DWR EXHIBIT M
Informal Submissions, Carl Nuzman
August 7, 2003

Subject: Wichita recharge and recovery

Wichita Aquifer Storage & Recovery
SHEET NO. _____ OF _____
CALCULATED BY Carl Nuzman DATE 7/17/03

Hydrograph of River and Groundwater Levels During pumping and nonpumping periods

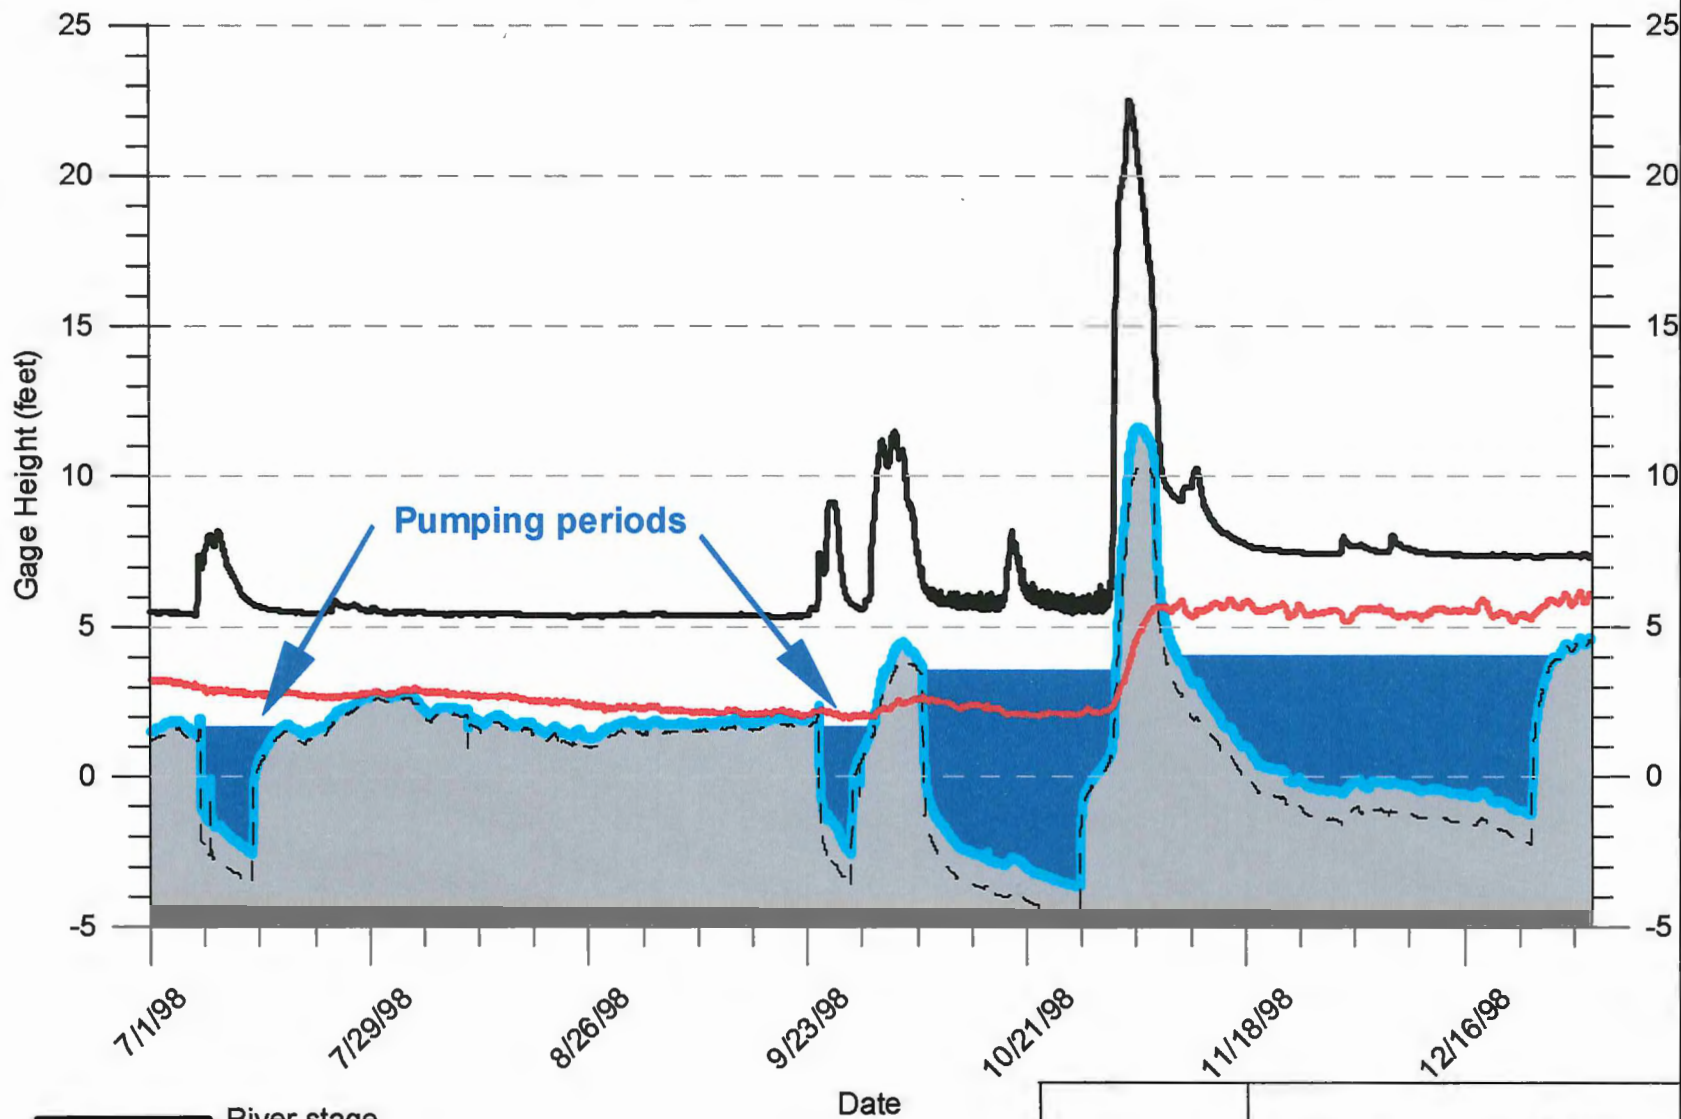
The concern of the consultant and several members of GMD #2 is that no direct communication between the Little Arkansas River and Channel to the Equus Beds aquifer exists at the test site.

The concept of pumping bank storage water only when 40 feet or more of low permeable clay exists between the water in the Little Ark channel and the aquifer is not requested nor accepted by ~~the~~ ^{this} consultant and was of major concern by several members of the GMD No 2.

The pumping of water for the recharge project was not in compliance with the terms and conditions of term permit File No 959087 in that most of the water pumped was Equus Beds aquifer water recharged from natural precipitation and not limited to "Bank Storage Water" only.

Figure I-21
DRAWDOWN
UPPER AND LOWER ZONES
SITE TH-04

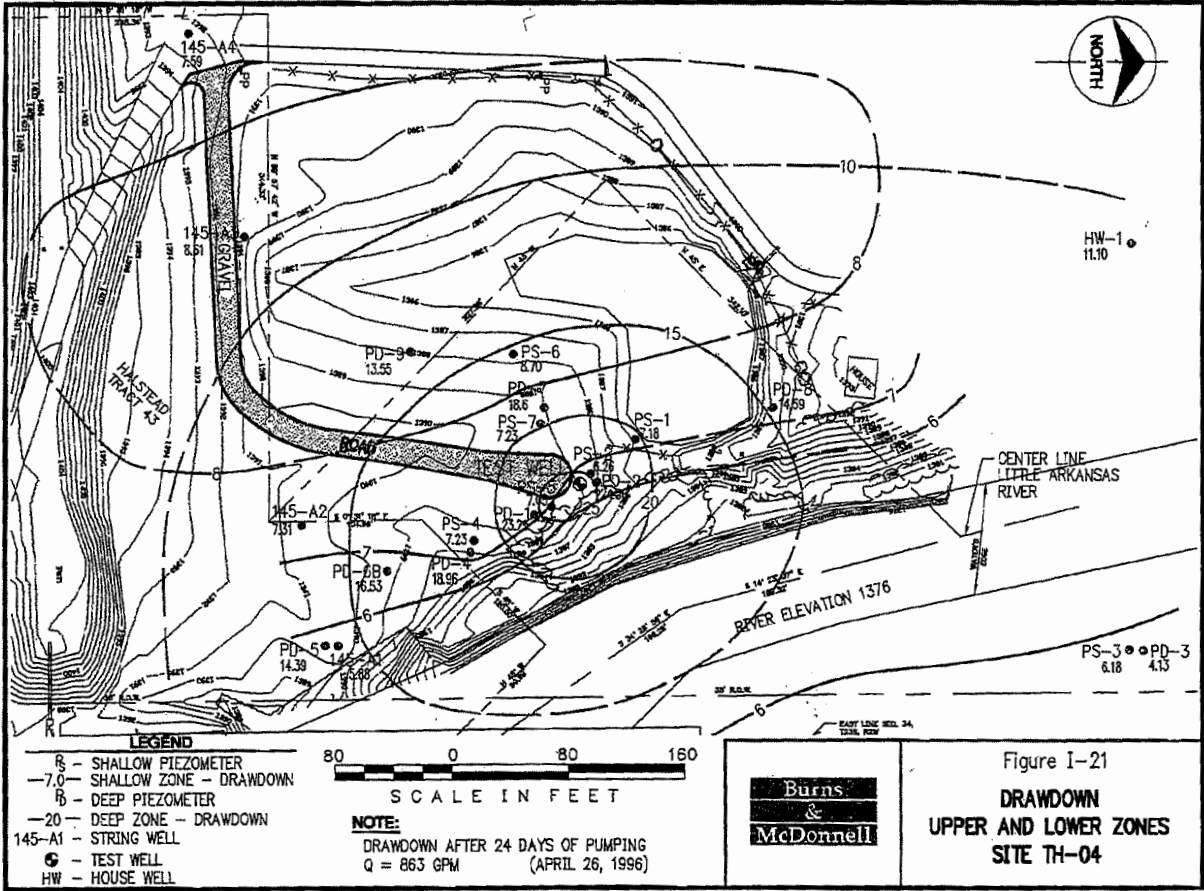
Initial concerns were expressed about the depth of the bank storage wells under the term permit for the pilot project. The wells are drilled to the base of the Equus beds aquifer and screened substantially below the streambed. It is his argument that well logs indicate low permeability clay layers of substantial thickness exist between the top of the screen and the stream, effectively eliminating the hydraulic connection between the wells and the water temporarily stored in the banks. He further argues that the present design merely withdraws water from one location of the Equus Beds aquifer and injects it at another location capturing no stream runoff water. Well log data submitted shows clay layers of about 30 feet with a thin sand layer of less than 10 feet above the clay. About 10 feet of clay also is shown between the stream bed and the sand layer.

His conclusion is that there is no practical opportunity to pump bank storage water from the clay adjacent to the stream.

Figure I-20
AS-CONSTRUCTED TEST WELL AT SITE TH-04.

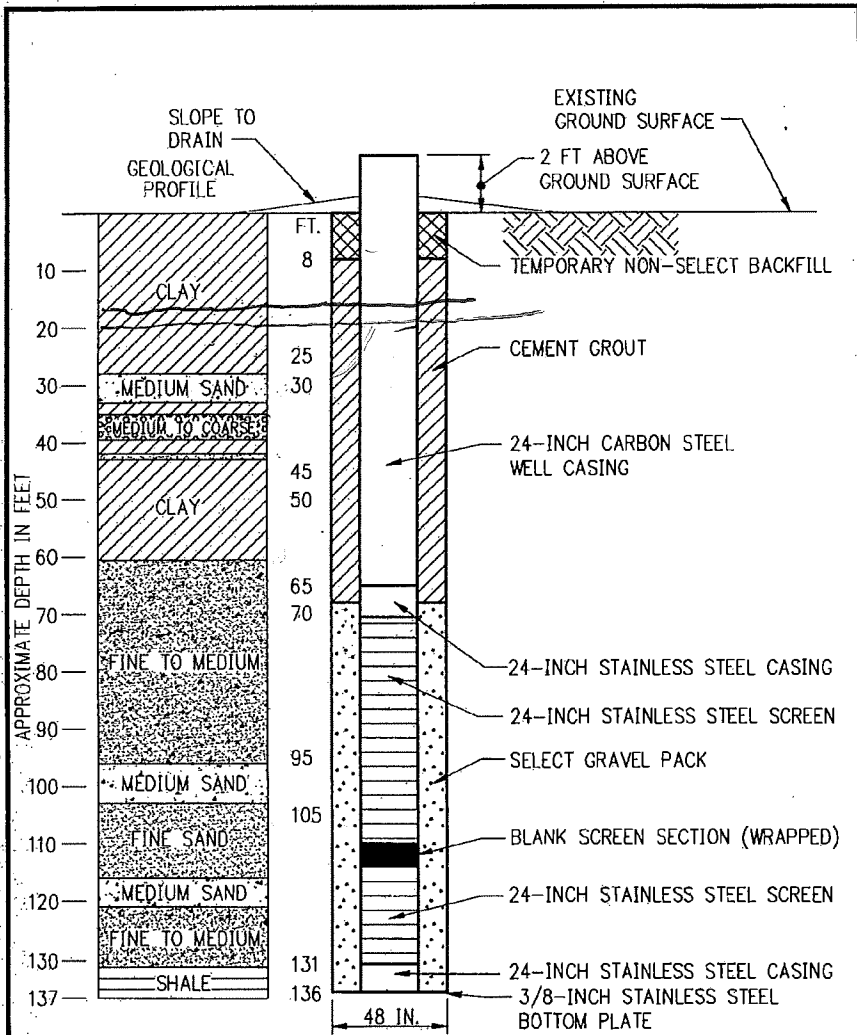
- 9) Final construction of the well shall maintain separation between the aquifer's upper and lower zones; ✓ figure
- 10) The use of Class V UIC recharge wells is authorized by the Kansas Department of Health and Environment and minimum water quality standards for effluent approved by the Department for organic and inorganic compounds, pesticides and bacteria are met;
